NEPEAN BAY

OUTFALL SEWER

RE: SUBSURFACE INVESTIGATION
NEPEAN BAY OUTFALL SEWER

Re: Soils Investigation - Nepean Bay Outfall
Ottawa Queensway

EFFECT OF PUMPING AT WELLPOINT (BOREHOLE 6D)

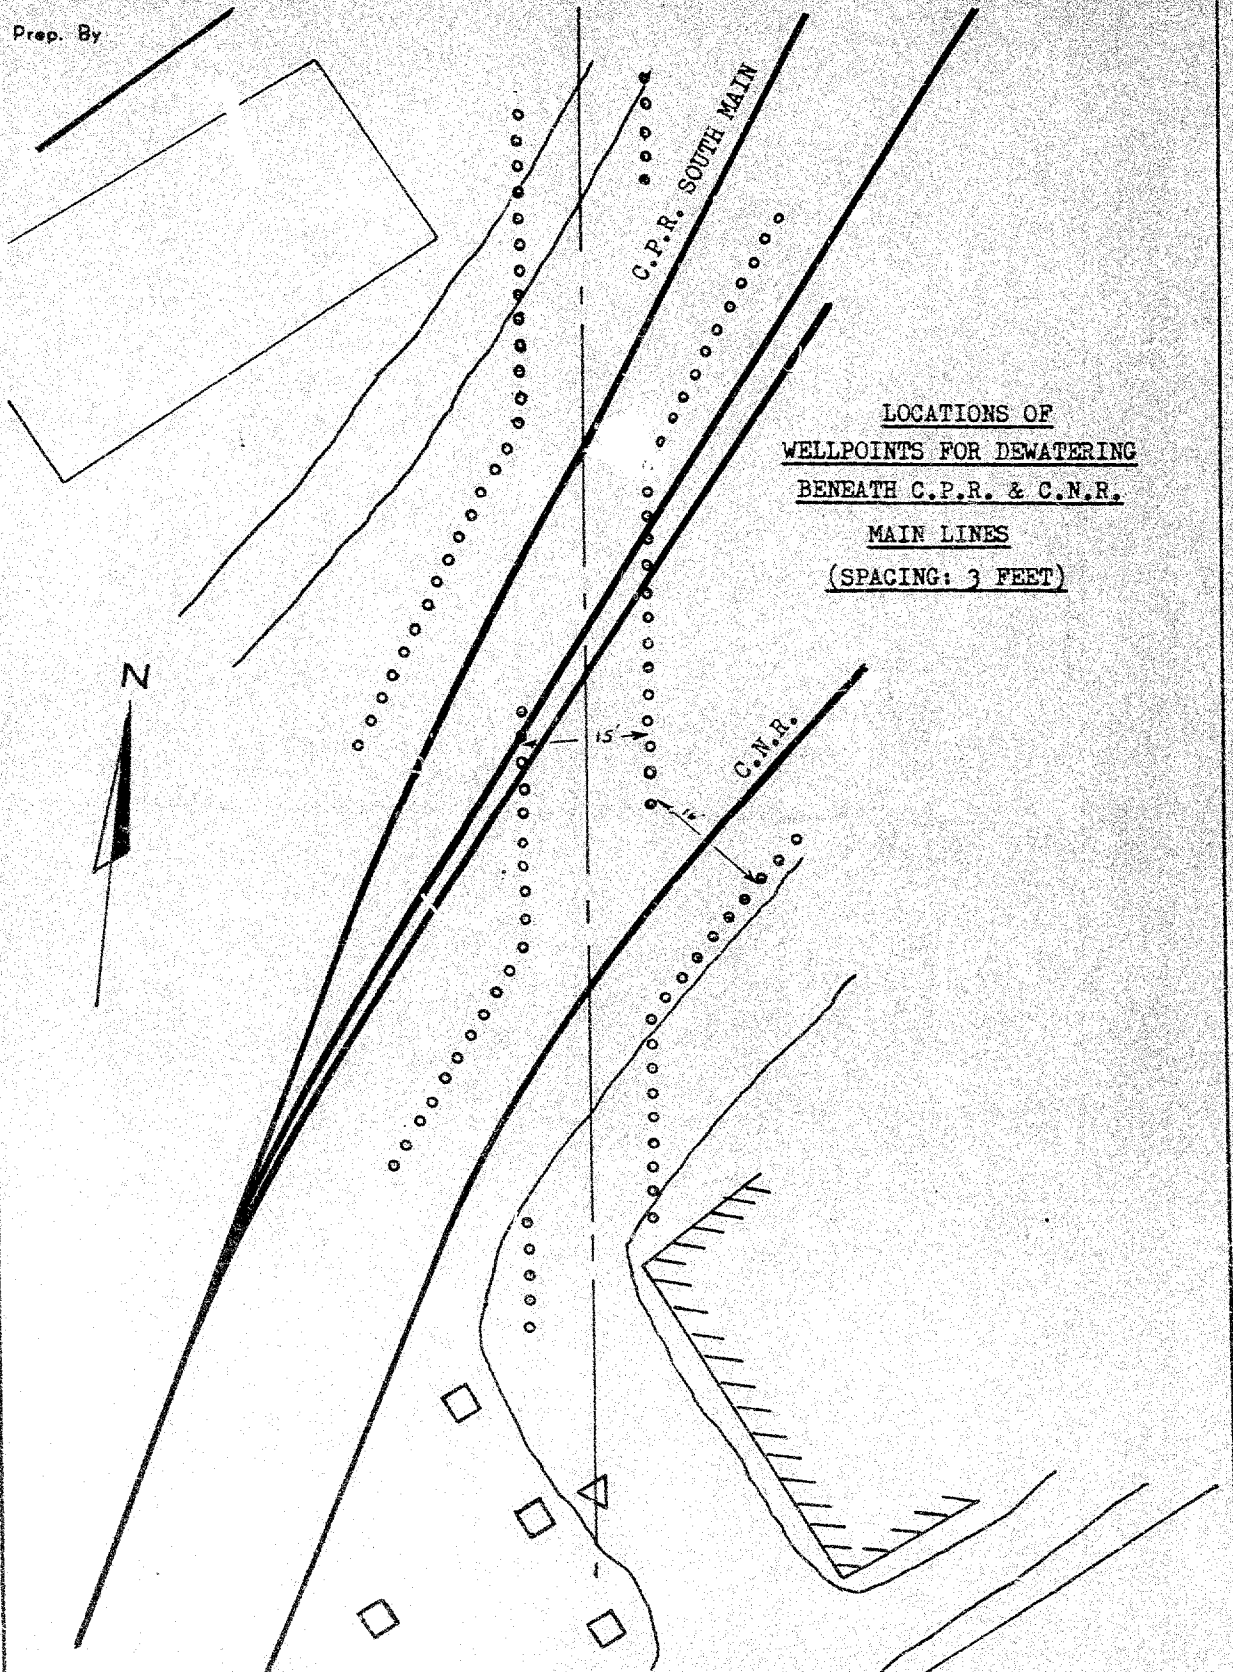
From the results of the tests, the relationship between drawdown from the normal ground water table and distance from the well-point was obtained and this is plotted in Enclosure 1. As a result of the high permeability of the medium, the phreatic surface, within the range of practical interest, is relatively flat.

The most relevant result of the test was that the ground-water table could be lowered twelve inches at a radius of about twenty feet from a normal well-point. Since the ground water may require to be lowered by as much as fifteen feet at certain locations, it will be necessary to have a minimum of fifteen well-points within a radius of twenty feet of these locations.

LOCATION OF BOREHOLES
IN C.P.R. YARD AREA.

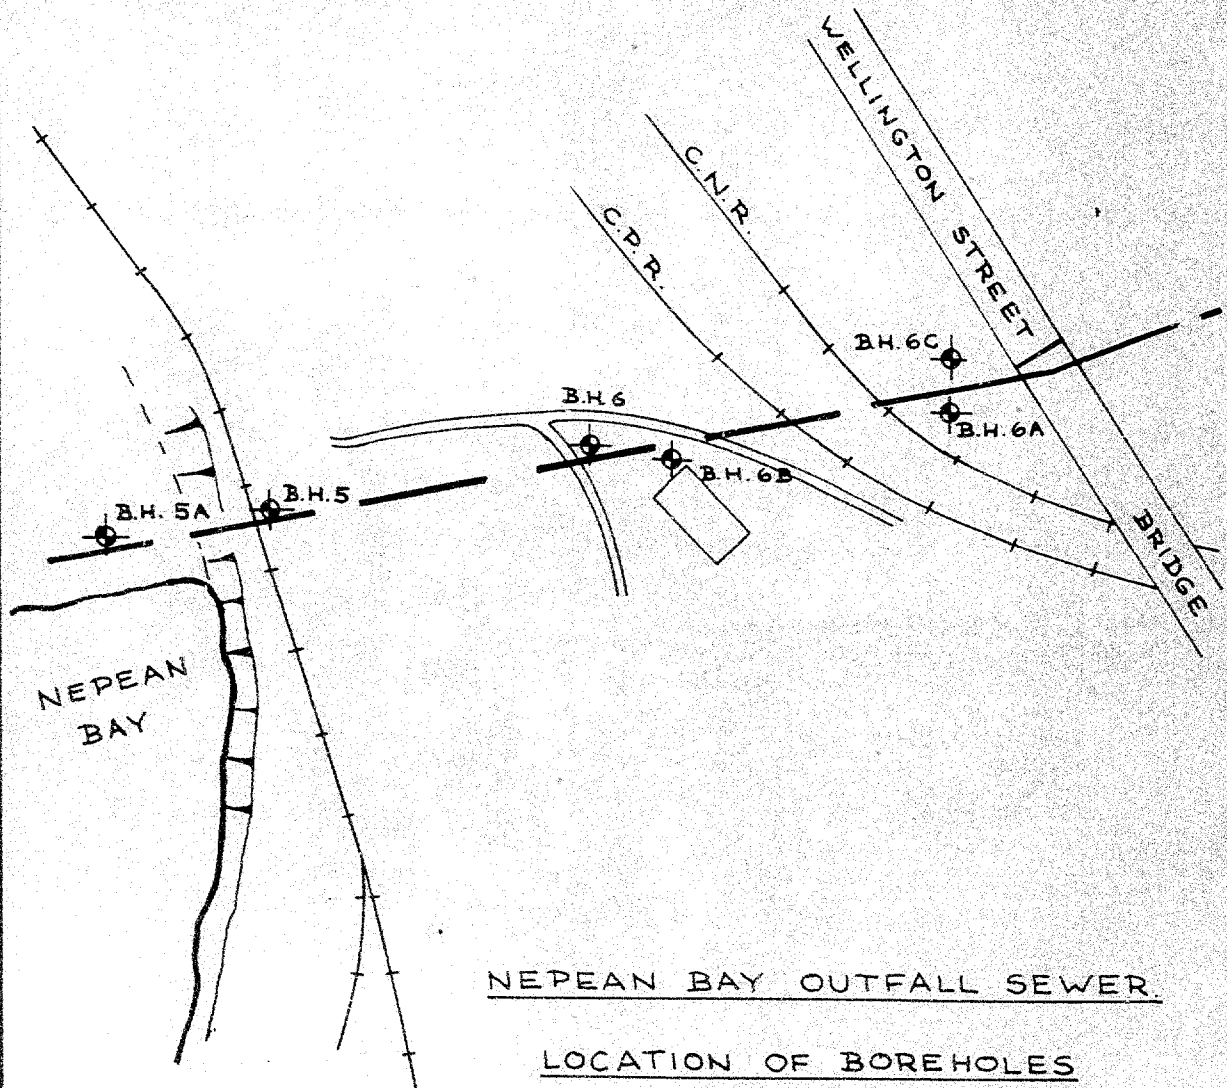
In connection with the above project, tests and observations have been carried out at certain boreholes in order to determine ground water conditions as they might affect tunnelling operations.

PRECEDING BOREHOLES

Boreholes 5 to 12 inclusive were primarily for the purpose of determining soil conditions and the water level observations in these holes were not any more comprehensive than in a normal site investigation. In actual fact, only Boreholes 5 and 6 were within the area in which tunnelling was likely and Borehole 6 was found to be entirely through fill on top of a City of Ottawa sewer running from east to west. The results of Borehole 6 were therefore considered to be not typical of the area as regards both soil and water conditions. (Seepage into and out of Borehole 6 was very slight, indicating that the large number of boulders in the fill had been mixed with a substantial quantity of impermeable, fine material.)

The series of borings undertaken after No. 12, was aimed at obtaining information about water conditions rather than details of the stratification. The results are summarized below:-

NEPEAN BAY OUTFALL SEWER
PROPOSED PROFILE AND
STRATIFICATION.

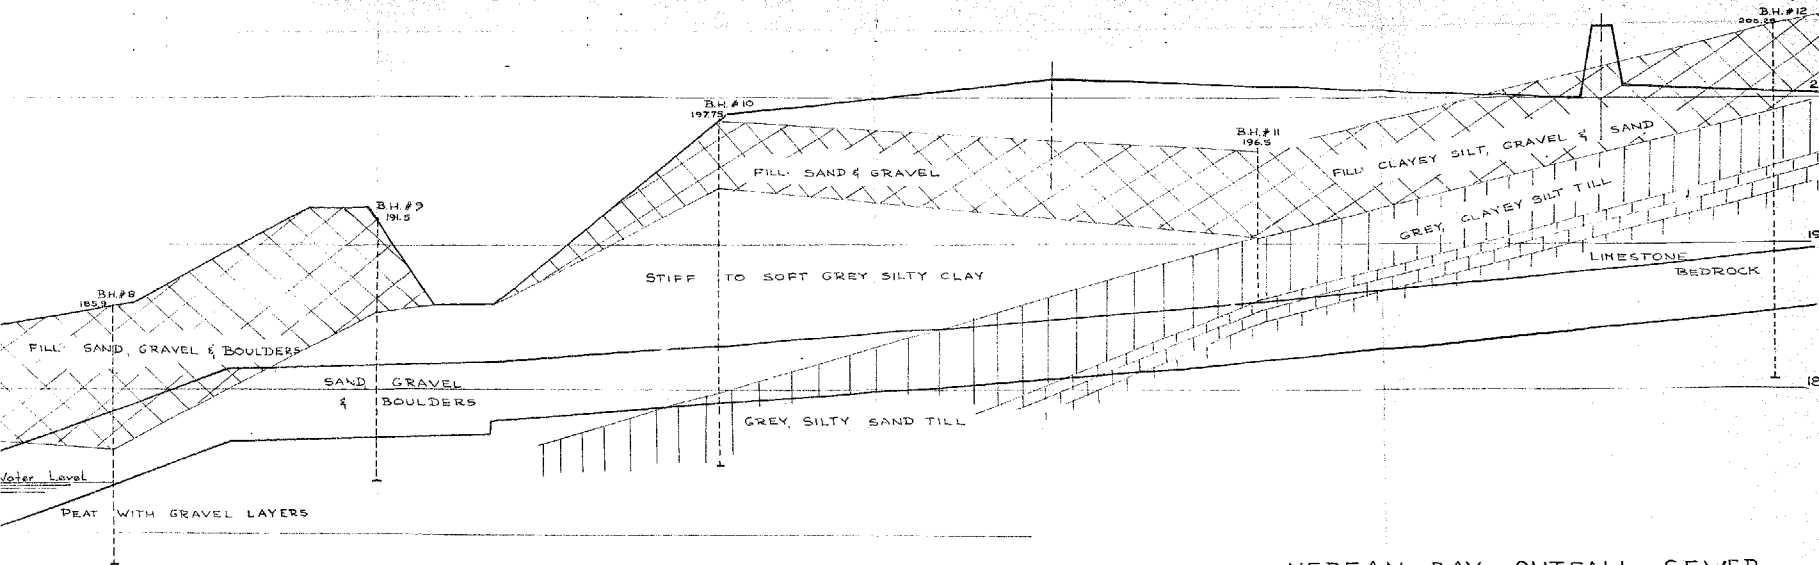
There would appear to be differences of a few feet between the elevations supplied for the ground surface at Boreholes 11 and 12 and the ground line on your profile. These boreholes are plotted at the elevations supplied by you.

However, your attention is particularly directed to the results of Boreholes 8, 9 and 10 where strata of totally different character, viz., peat, sand, gravel and boulders and clay respectively were encountered around the depth at which the proposed sewer is to be

laid. Since each of these strata occur at one borehole only, it is not possible to indicate strata boundaries with any confidence. Further intermediate borings would therefore seem to be indicated.
